**PLANNED UNIT DEVELOPMENT
STAFF REPORT****Date: July 11, 2013****DEVELOPMENT NAME**

Joco 2928, LLC

LOCATION2928 McVay Drive
(East side of McVay Drive North, 470' ± North of Halls
Mill Road).**CITY COUNCIL
DISTRICT**

CONTEMPLATED USEPlanned Unit Development Approval to allow shared
access and parking between two building sites.**TIME SCHEDULE
FOR DEVELOPMENT**

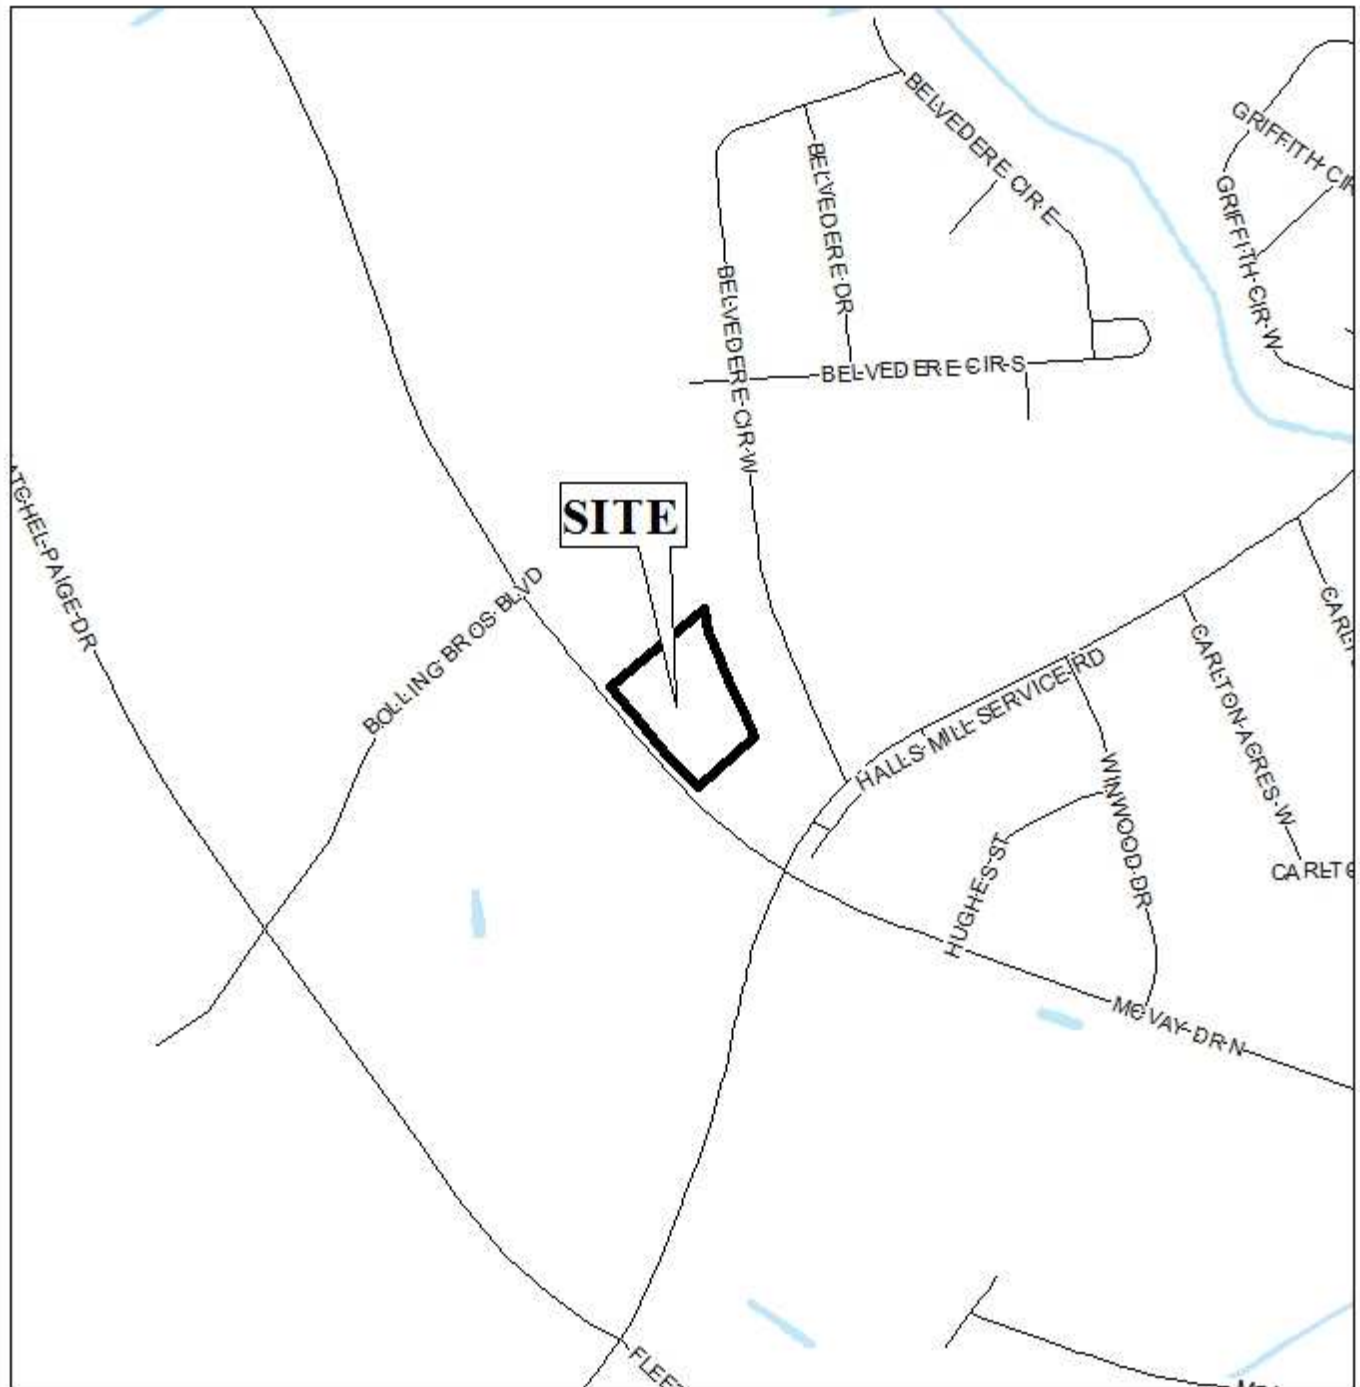
The Western lot (Lot 3) is currently developed as an office with warehouse space. A 2,400 square foot addition and elimination of the warehouse use is proposed, with additional parking to be provided. The Eastern lot (Lot 2) is currently undeveloped, and an 8,400 square foot building is proposed. However, it should be noted that there are two notes on the proposed site plan regarding parking for Lot 2 that identify the usage of the proposed building differently. One note identifies the building as office only, while the other indicates it will be occupied by an office and warehouse. It appears that between the two lots, adequate parking will be provided regardless of which of these two proposed uses is correct, however, the site plan should be revised to clearly and accurately indicate the use of the building on Lot 2. Also, it appears that

while handicapped parking spaces are proposed for both sites, neither illustrates a van accessible handicapped parking space as required by the Americans with Disabilities Act.

A condition of the Subdivision and Rezoning requires a uniform 6' high privacy fence to be provided at the rear of each lot due to the adjacent residentially zoned property. Such a fence is therefore illustrated for Lot 3, no such fence is indicated for Lot 2; the site plan should be revised to indicate the required fence as either existing or proposed. The site plan does illustrate a 20' vegetation buffer at the rear of both lots as required by Subdivision and Rezoning requirements, which should be retained on the site plan.

The site plan illustrates several existing and proposed trees; however, the site appears to be short 1 frontage tree. Also, the site plan submitted states the landscaping data for Lot 2, but does not give the same information for Lot 3. While Lot 3 was reviewed for tree and landscaping compliance when the site was initially developed in 2003, the currently proposed addition will remove some landscaped area. Therefore, landscape calculations should be provided for Lot 3 to insure compliance is maintained.

A sidewalk is illustrated along McVay Drive for Lot 3, but not Lot 2. Either a sidewalk should be illustrated for both lots, or a sidewalk waiver should be submitted.

It should be noted that the legal description provided on the site plan only identifies one of the two lots included with this application. If approved, the site plan should be revised to include the legal descriptions for both lots.

- 1) clearly and accurately indicate the usage for the proposed building on Lot 2;
- 2) revision of the site plan to indicate a 6' high privacy fence at the rear of Lot 2;

- 3) retention of the 20' vegetation buffer at the rear of both lots;
- 4) revision of the site plan to illustrate full compliance with tree and landscaping requirements for both lots;

- 6) illustration of a sidewalk along McVay Drive for Lot 2, or the submission of a sidewalk waiver;
- 7) revision of the site plan to include the legal descriptions of both lots included in this application;
- 8) submission of two copies of the revised Planned Unit Development site plans to Urban Development.
